Determination 2023/030

The issue of a building consent, specifically in regard to three cladding details.

400 Aberdeen Road, Gisborne

Figure 1: Detail DG02 from The Brickery Design Note A2.

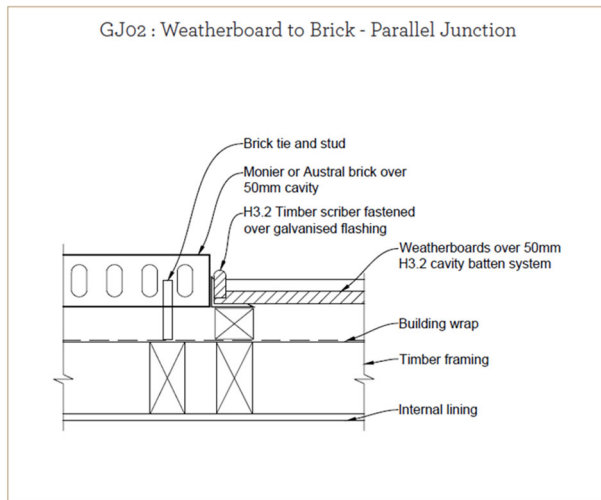
4.22. In terms of the technical trade literature, E2/AS1 does not provide a detail for the junction of an infill panel butting into adjacent brick veneer. However, an example of one provided by the brick veneer industry is Detail GJ02 (see Figure 1). Detail GJ02 has three components to it:

4.22.1. a 50mm packer is shown to bring the rear of the cladding in line with the rear face of the brick veneer.

4.22.2. a scriber to close the junction between the cladding and brick veneer.

4.22.3. a back flashing to capture and control any water penetrating into the junction.

4.23. Detail 2 has similar components, although the flashing is installed to a different configuration and the packer is fixed horizontally. Detail 2 also has additional components, that being the cavity battens on top of the packer and on the face of the building wrap to support the flashing.

4.24. I consider that Detail 2 reflects the intention of the industry detail and compliance with clause E2.3.2 can be expected. This is because:

4.24.1. The difference in the packer depth is immaterial, as its only purpose is to bring the cladding forward to enable a butt joint between the two claddings. The packer size will depend on the actual depth of the veneer cavity, as well as the desired line of the infill panel cladding.

4.24.2. The packer orientation is immaterial as it is a practical requirement to support the selected cladding.

4.24.3. The difference in cladding type is also immaterial, as it is the junction between two dissimilar claddings that is the location where water is more likely to penetrate the cladding.

4.24.4. The scriber is in the same location and serves the same purpose in both details, although a scriber can be expected to have a better fit to a flat sheet such as the proprietary panel cladding than to a variable surface such as that created by bevel back weatherboard. A better fit reduces the likelihood of water penetration.

- 4.24.5. A flashing is provided to the rear of the scribe/cladding junction in both details. As with the industry detail, the Detail 2 flashing will capture any water penetrating the junction.
- 4.24.6. The benefit of the flashing location and the provision of the cavity batten in Detail 2 is that these allow air to more easily circulate up to the rear face of the panel and the junction to assist with absorption and drying of moisture that has penetrated at this point. In turn, this reduces the requirement for drainage provision.
- 4.25. Therefore, I consider that Detail 2 complies with performance requirement E2.3.2 by way of an alternative solution.

Detail 1 - Brick veneer with panel cladding above window

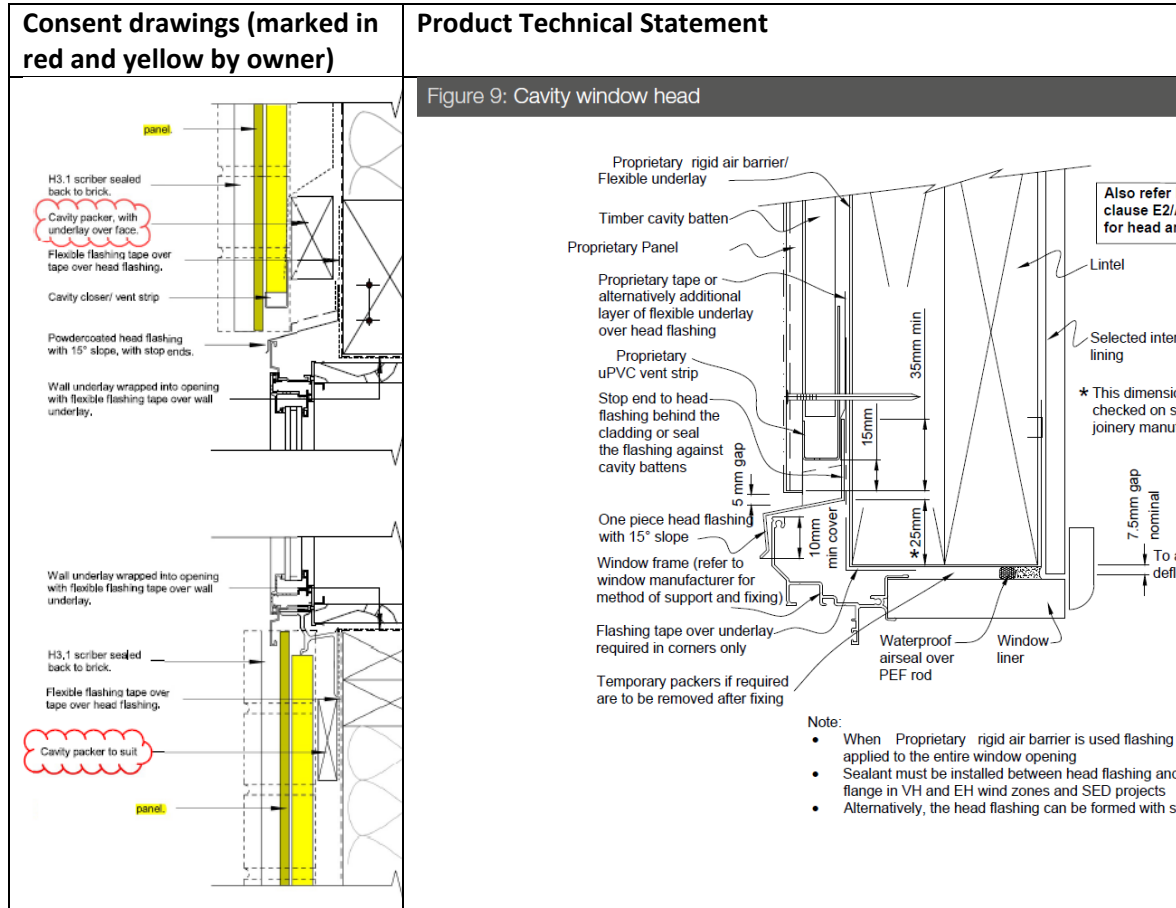
- 3.2.1. Written specification states the panels are to be installed over a 20mm cavity.
- 3.2.2. Manufacturer specifies cavity depth is 20mm.
- 3.2.3. In contrast, the approved drawings show cavity depth above windows and above the garage door at 65mm (batten depth 20mm + cavity packer 45mm), and below windows at 40mm (batten 20mm + packer 20mm).

- 3.2.4. The manufacturer specifies cavity battens are to be fixed by the cladding fixings to the main framing over the building underlay, and the panels be fully supported by vertical battens over the framing (refer to Appendix A Figure 3). This would achieve a 31mm depth of the fixings into the framing timber.
- 3.2.5. The approved drawings show 45mm horizontal packers above windows and the garage door head, and 20mm cavity packers below windows – with unsupported vertical cavity battens spanning the face. The building wrap is shown in the main framing line then dressed out over the horizontal packer. The result would be fixings through the 45mm packers into the cavity rather than into framing timber, and fixings through the 20mm packers would only achieve a depth of 11mm in the wall framing.

- 3.2.6. No fall was specified to the top of the horizontal cavity packers.
- 3.2.7. The manufacturer specifies a 5° minimum fall for spacers/packers.
- 3.2.8. E2/AS1 E2/AS1 figure 67. 5° min fall required for sloping spacers.

4.16. Figure 116(a) of E2/AS1⁶ is the “deemed to comply” head flashing detail for fibre cement sheet. In terms of comparison with the acceptable solution, Details 1 and 3 (with the exception of the 70x45 H1.2 packer), are essentially the same as the E2/AS1 detail. I note that they are not as well annotated or dimensioned as Figure 116(a), with text not being provided to describe the following on one or both of the details:

4.16.1. additional wall underlay from overlap above lapped over flashing.

4.16.2. cavity spacers set to fall where required for sheet fixing.

4.16.3. cavity closer positioned to give 15mm minimum drip edge to cladding.

4.16.4. 10mm minimum cover to joinery.

4.17. However, by scale and by consideration of what is drawn, it is my opinion that these items are all provided within the detail, except the provision of cavity spacers for

bottom edge fixing. I note that the product technical statement covering the proprietary panel cladding for cavity batten installation shows the bottom edge fixing in the order of 75mm above the bottom sheet edge. Therefore, the bottom fixing would be into the 70x45mm packer.

4.18. The only material difference between Details 1 and 3 and Figure 116(a) is the increased size of the cavity created by the 70x45mm packer, being 65mm rather than 20mm. However, I do not consider that the increased depth of the cavity has any adverse effect on compliance with clause E2.3.2. This is because:

4.18.1. If anything, it improves the level of compliance by providing a greater volume of air that is able to absorb water, thereby improving the drying of any free water that has penetrated into the cavity and reducing the requirement for drainage provision.

4.18.2. The means of managing any surface water located on the building wrap against the wall framing shown in Figure 116(a) is replicated in Details 1 and 3. Building wrap is shown lapping over the packer from above. If any free water did penetrate, was not dealt with by drying, and was located on the building wrap against the wall framing, it would be directed into the 20mm cavity between the packer and cladding. Then, it would be drained via the vent strip over the head flashing.

4.19. As described above, the variation of Details 1 and 3 from what is specified in E2/AS1 will not have any adverse effect on the details' ability to meet performance criteria E.2.3.2. Therefore, I am of the view that Details 1 & 3 comply by way of an alternative solution.

4.20. Detail 2 shows the vertical junction between the infill panel and the adjacent masonry veneer, with the infill butting into the veneer.

- 4.32. I acknowledge that the details in question, particularly Detail 2, do not specifically show a vertical member over the framing to provide support.

- 4.33. The manufacturer's installation guide for the cladding states "The framing must fully support all panel edges".
- 4.34. Therefore, a vertical support member is required between the 90mm x 45mm wall framing and the vertical cavity batten.

- 4.35. Detail 2 lacks clarity on this requirement. However, it does not contradict the construction details as provided in the cladding manufacturer's installation guide, which indicate that vertical support is required.

- 4.36. The manufacturer's installation guide was freely available, and it is reasonable to expect that a builder would be aware of and would utilise that guide.

- 4.37. A building's design is communicated through a combination of drawings, specifications and supporting documents, such as product manufacturer's installations guides, etc. None of these documents in isolation are intended or expected to provide a complete set of instructions. They are a suite of documents which are used in combination by a builder.

- 4.38. Finally, the proposed assembly of the packers with cavity battens over does not prevent the cladding from being fixed in the manner that is specified by the cladding manufacturer, as noted in Table 2 of their installation guide.
